PLANT NAME: Turkey Point Units 3 & 4

Re: Turkey Point Plant Units 3 and 4
Docket Nos. 50-250 and 50-251

In accordance with 10 CFR 50.59, Florida Power & Light Company (FPL) submits herewith three signed originals and 19 additional copies of a request for authorization of a change in Technical Specifications attached as Appendix A to Facility Operating Licenses DPR-31 and 41.

Figures 6.1-1 thru 6.1-3

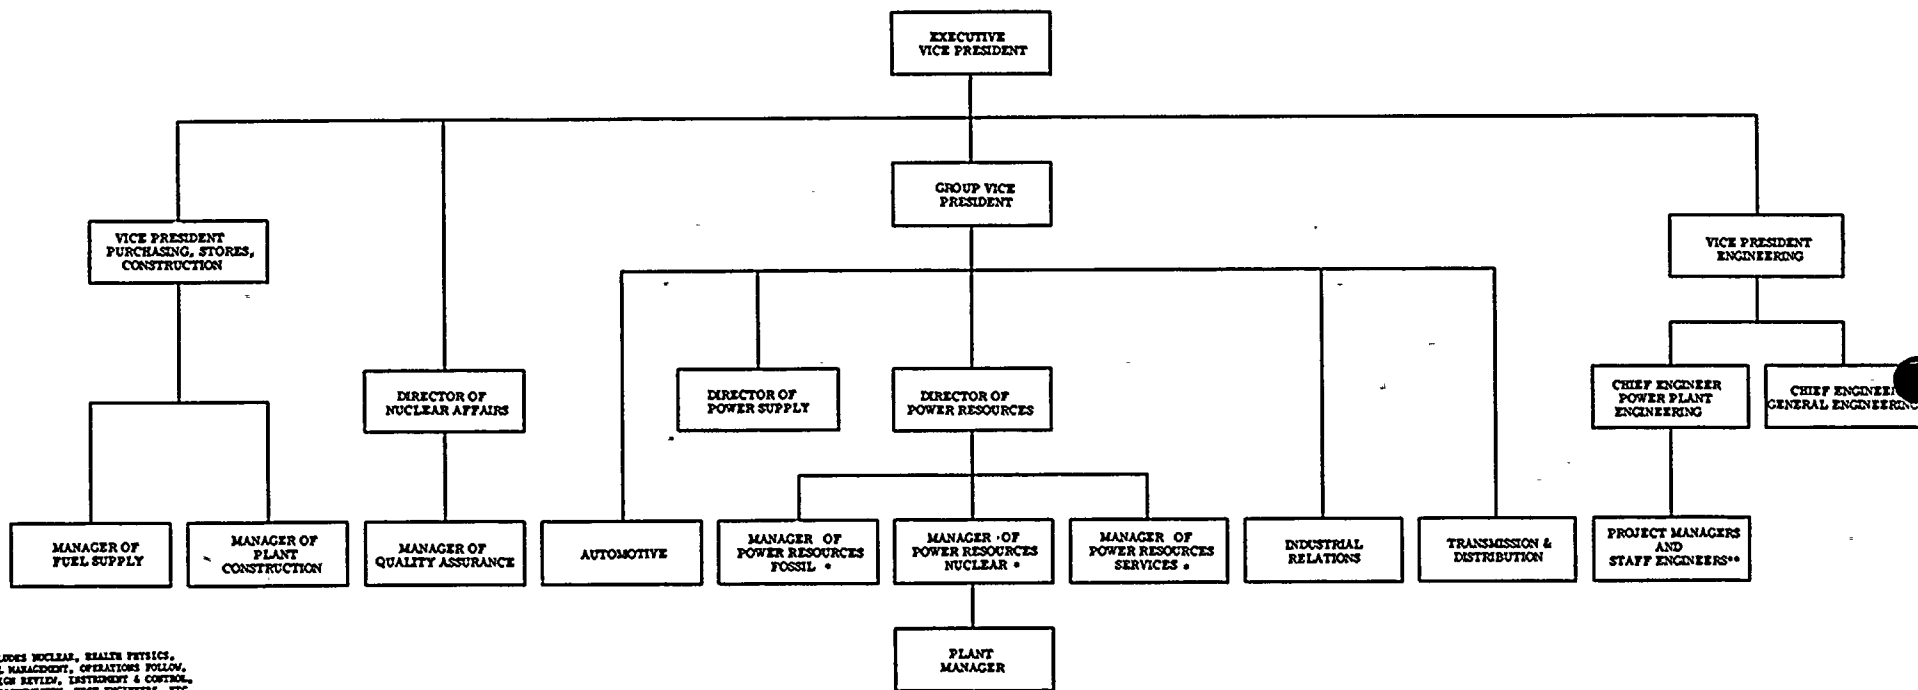
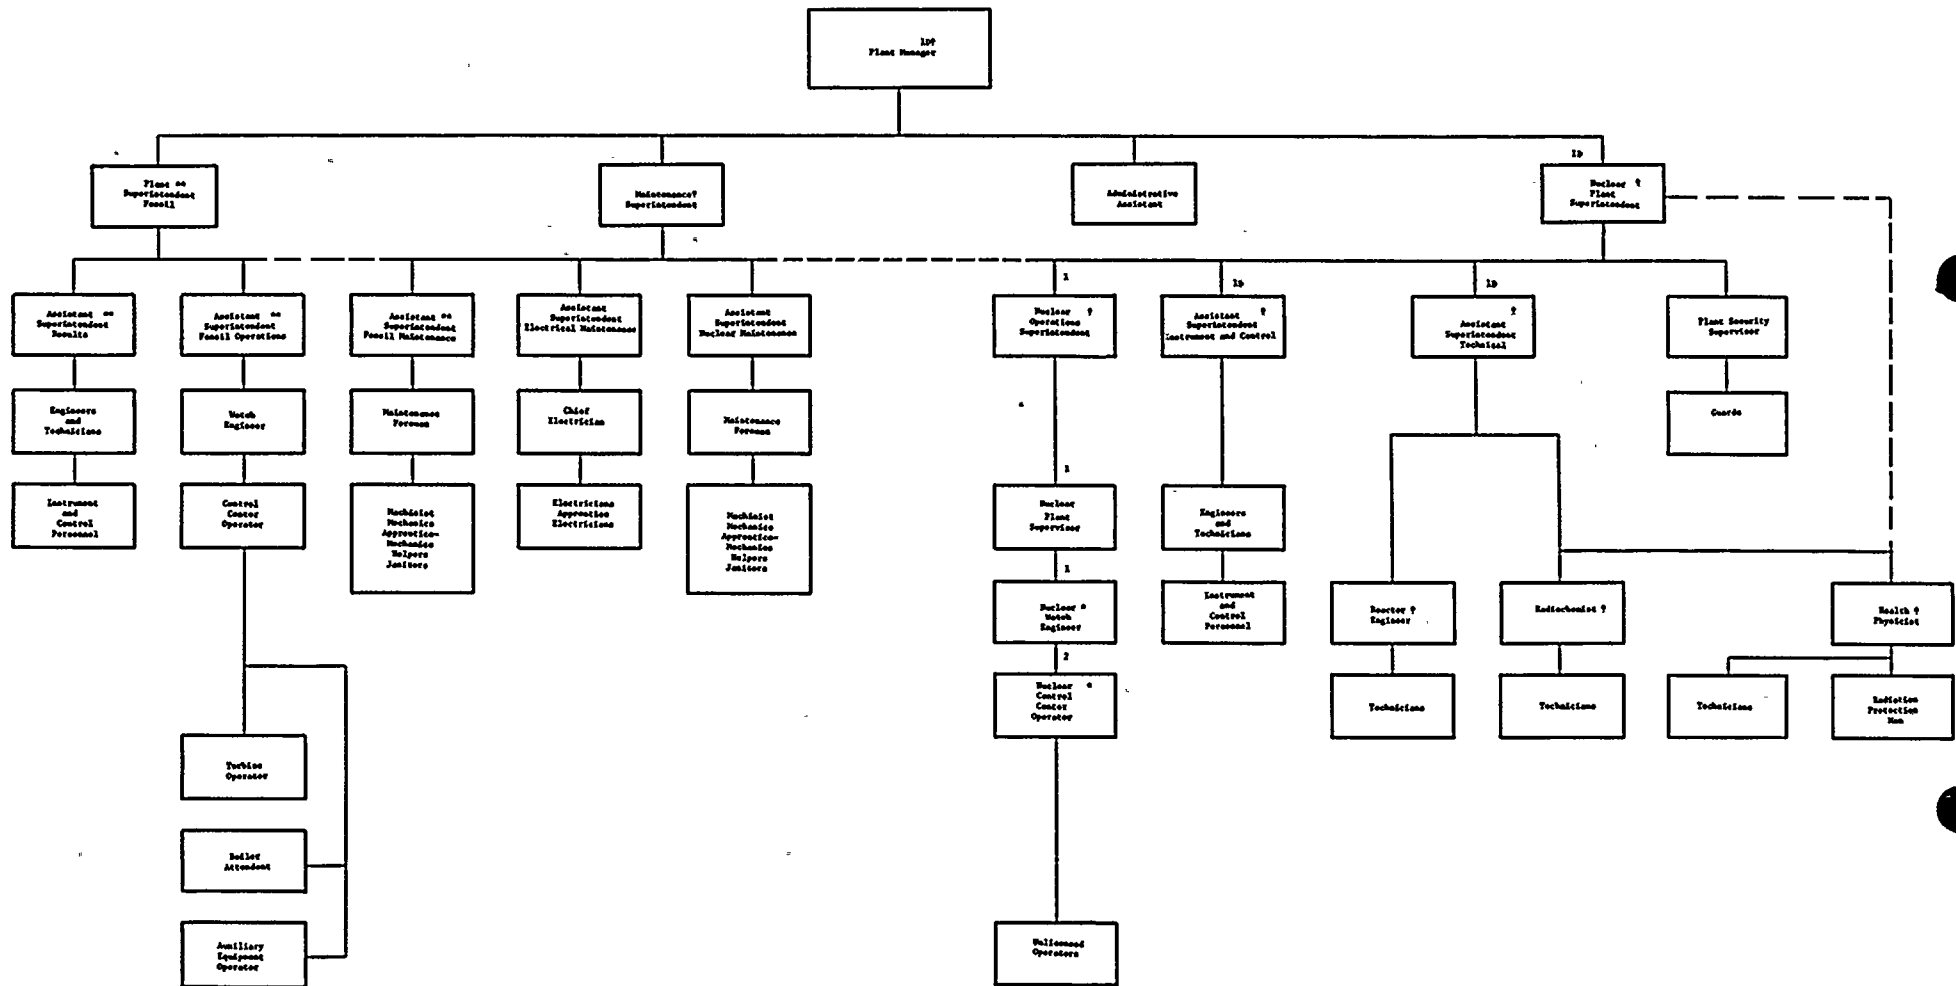
These have been updated to show the current organization and titles.
